August 28, 2018

**Re: Planning Rationale Addendum Letter to Site Plan Control Application for 800 Eagleson Rd,
5264 Fernbank Rd (Application No. D07-12-18-0096)**

Fig. 1 – revisions to original site plan submitted 2018/06/15

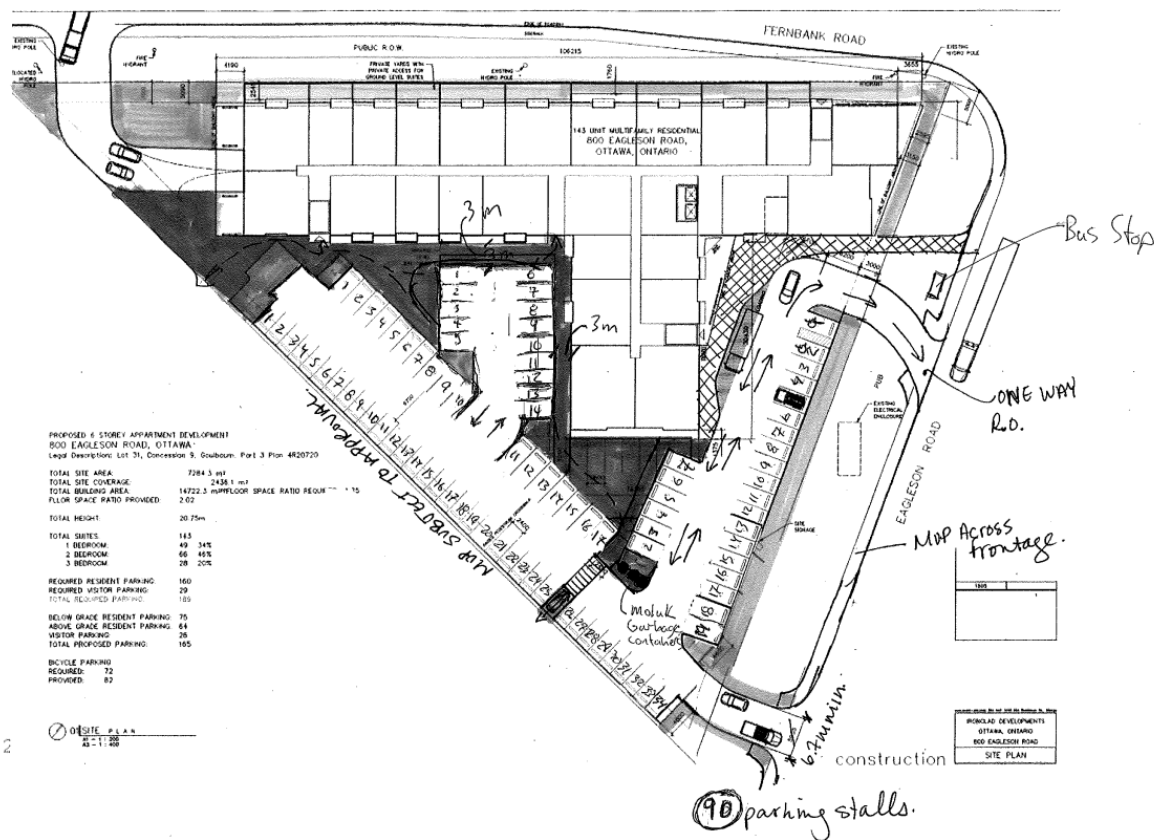
Since the original application was submitted, a revision to the site plan has been made with respect to the parking layout and the amenity space in the rear yard. These revisions were made in response to comments made by members of the Urban Design Review Panel ('the panel') at ICD's hearing at the panel on July 5, 2018. Among the panel's concerns were the following:

- Incompatibilities with the drop-off area and the parking lot in front of the primary entrance off Eagleson Rd;
- Issues with the site's internal circulation; particularly for fire trucks and other large vehicles;
- The large amount of surface parking in the rear yard, resulting in isolated pockets of landscaping/amenity space; and
- The lack of a landscaped buffer between the building's exterior walls and the hard-surfaced parking area

The outdoor surface parking configuration has been modified to improve circulation as well as to better integrate the amenity areas with the building. The primary entrance off Eagleson Road has been moved further south in order to add a secondary 'right-out only' exit. The amount of surface parking has been reduced by eight (8) spaces, greatly simplifying the parking circulation and reducing the chance of collisions – especially collisions involving larger vehicles. Additionally, the laneway connecting the surface lot to the Fernbank Road entrance has been closed; all incoming vehicles utilizing this entrance is directed to the underground parking garage.

The reduction to the surface parking area facilitates an increase in the amounts of landscaped greenspace. The buffer between the building's exterior and the parking has been increased to three metres. An interconnected pedestrian pathway now connects the main entrance to the refuse containers and the proposed multi-use pathway atop the landscaped berm. In addition, the new surface parking layout results in new landscaped 'islands' which not only adds shared outdoor amenity space, but also helps break up the size of the surface parking lots and aids in orientation.

As mentioned previously, the total number of parking spaces has been reduced from the original submission from 172 to 164, resulting in a parking ratio of 1.15 spaces per unit. It is important to note that the required parking rate for disabled spaces remain unchanged. As such, ICD intends to seek approval from the City of Ottawa Committee of Adjustment to approve three
